Determination 2017/002

Regarding the requirement for fire resistance of a slatted timber deck over a car parking area to new townhouses at 350 Colombo Street, Christchurch

This determination considers whether the proposed deck construction would comply with Clause C3 of the Building Code. The determination discusses whether the timber slatted deck over a carport is a roof for the purpose of C/AS1 and whether the design is an alternative solution.

Figure 1: Sectional view of proposed construction

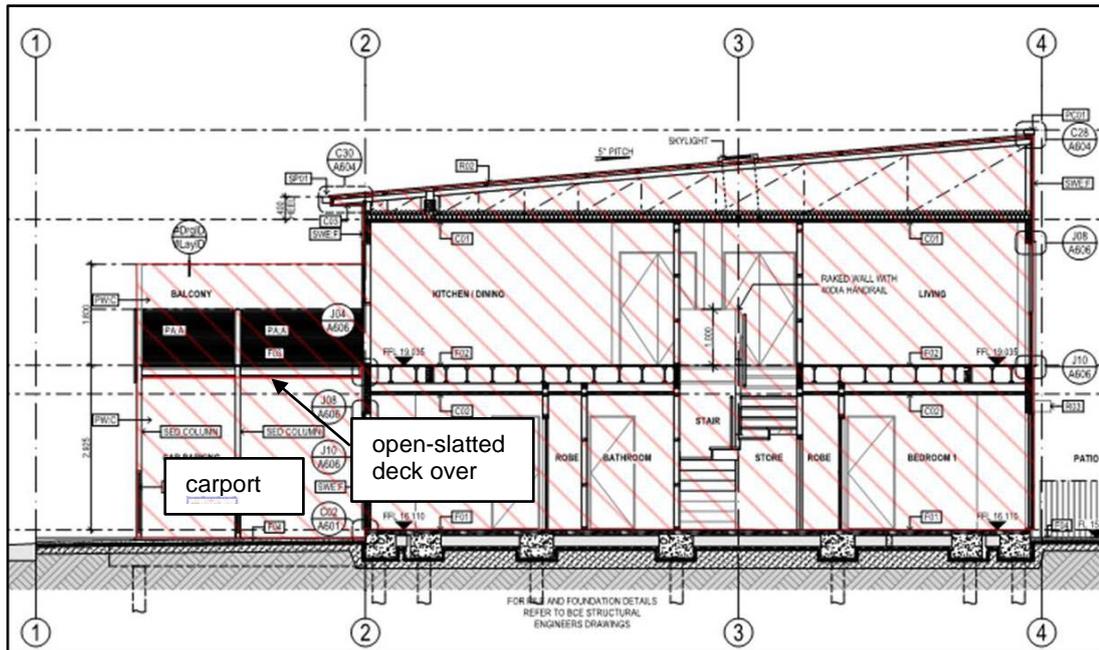
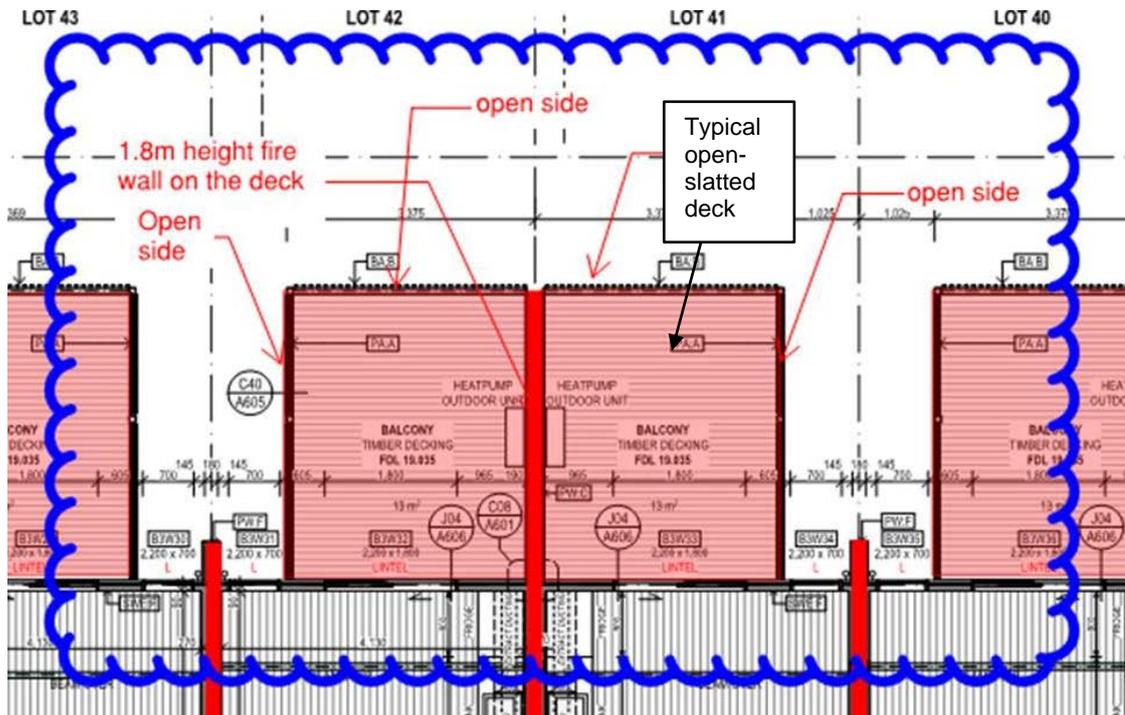
- 5.3.1 The carport is fully open on two sides, and on the boundary between adjacent properties there is a 30/30/30 fire wall along the full length of the carport that runs up to 1.8 metres above the level of the deck. Any fire in the carport would be vented to the outside via the two open sides and up through the unrated open-slatted deck.

- 5.3.2 In the absence of any of the proposed carport structure (the deck and the boundary fire wall), a fire in a carpark space would affect adjacent property to a limited extent as the effects of fire would vent to open air.

- 5.3.3 The presence of the 30/30/30 fire wall between carparks and the open deck means that that only the upper level of the adjacent property might be adversely affected by fire and to no worse an extent as if the deck and wall were not there.

- 5.3.4 It is my opinion that a fire in the open space would not generate sufficient heat to threaten the adjacent unit above, due to separation distance and angle; however this would need to be verified by calculation.

- 5.4.1 Taking into account the evidence outlined above, I conclude that:
- the deck above the car pad constitutes a “roof” for the purpose of C/AS1 and the design does not comply with C/AS1;
 - it is unlikely that the balcony requires fire protection in order to comply with Clause C3.6 of the Building Code, though this requires calculation to verify.

- 6.1 In accordance with section 188 of the Building Act 2004, I hereby determine that pending verification the slatted decking over carport as proposed for this building will comply with the Building Code Clause C3 Fire affecting areas beyond the fire source.
